**Change Notification #:** 113594 - 00  
**Change Title:** Intel® Server System R2208GL4GS  
PCN 113594-00, Product Design  
Update the System Rear Panel, Resistors and  
Capacitor  
**Date of Publication:** January 23, 2015

Intel is implementing the following changes on the Intel® Server System R2208GL4GS:

Figure One

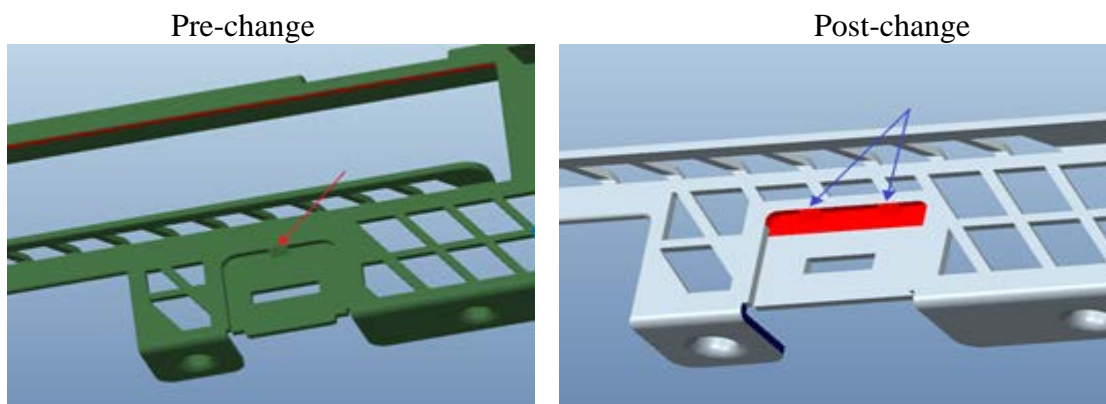
1. Update the one big center joint to two smaller joints so that the joints will not conflict with the LAN cable connector latch. See Figure One.

Figure Two

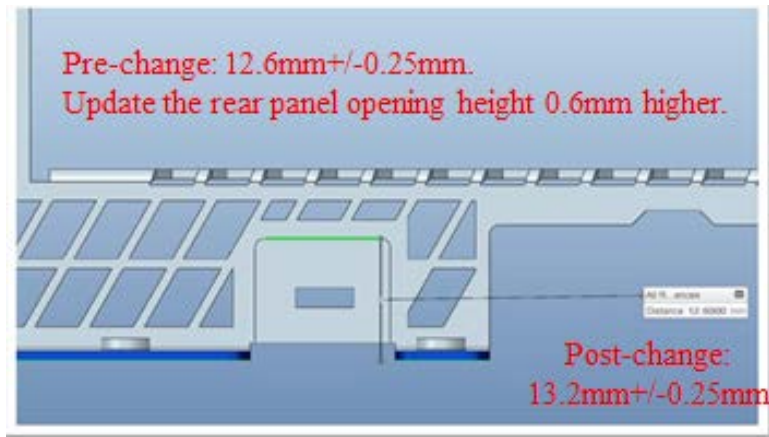
2. Update the rear panel opening height 0.6mm higher to improve the flexibility for the cable latch. The previous height was 12.6mm $\pm$ 0.25mm. The updated height is 13.2mm $\pm$ 0.25mm. See Figure Two.

Figure Three

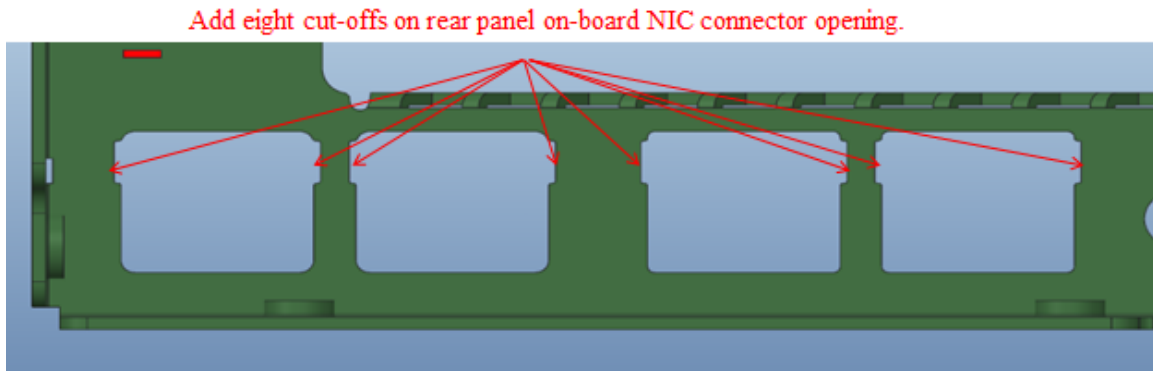
3. Add eight cut-offs around the on-board NIC (Network Interface Controller) openings to improve the LED visibility. See Figure Three.

Figure Four. Component Locations for the 2U Riser Spare A2UL8RISER

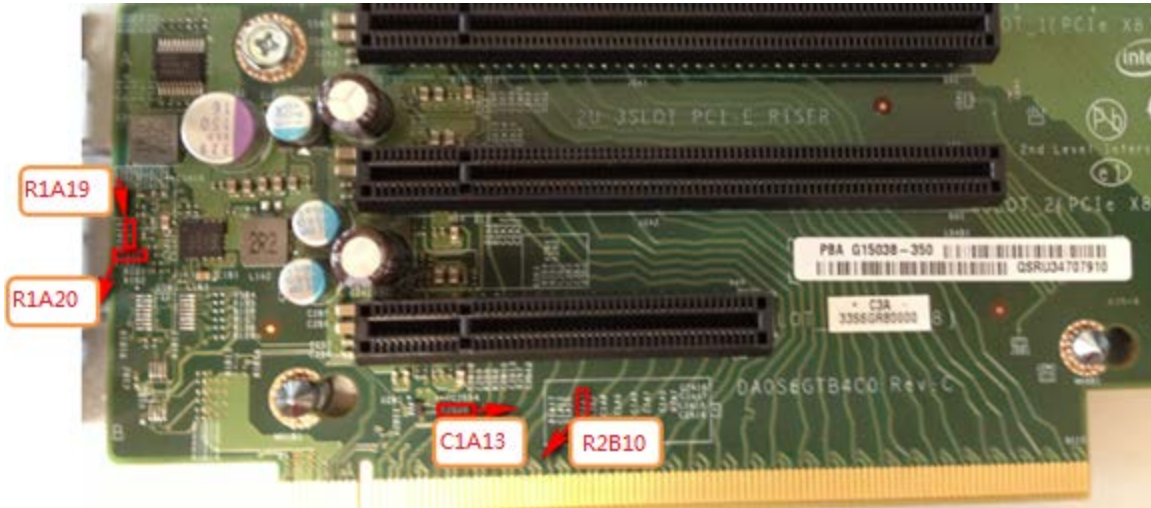
4. Update the following resistors and capacitor (see Table One and Figure Six) on the 2U PCIe Riser Spare A2UL8RISER to make an improvement to support a higher 3.3 Voltage Regulator startup over current. Before this change, the Voltage Regulator on the riser card may not be able to turn on when the total current drawn is more than 5A current. After this change, the Voltage Regulator on the riser card can support more than 10A current.

Component	Location	Pre-change	Post-change
Resistor	R2B10	10.00 kOhm	3.65 kOhm
Resistor	R1A20	0 Ohm	30 Ohm
Resistor	R1A19	40.20 kOhm	20.00 kOhm
Capacitor	C1A13	10.00 pF	120.00 pF
